# D0 SCL Receiver Preliminary Specification

## **Revision 2 (9/4/98)**

P1 and P2 footprint (surface mount connectors). [see note on first page (revision 2) concerning addition of connector alignment holes]

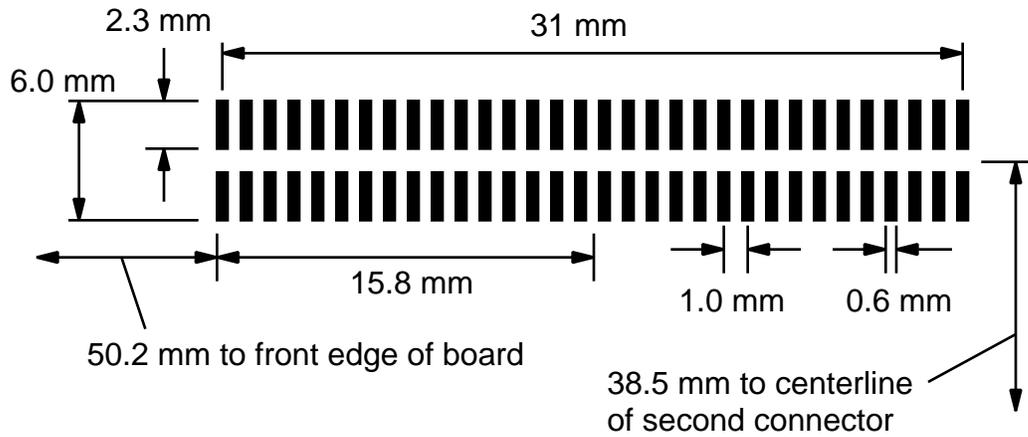
**(Revision 2) - it has been pointed out that there is a potential for misalignment when using the originally specified connectors, if the connectors float during surface mounting. It may be preferable to use the connector version with PCB pegs (Molex 71436-0164) for more precise alignment. This requires adding two reference holes to each connector footprint (see above Molex URL for size and placement information).**
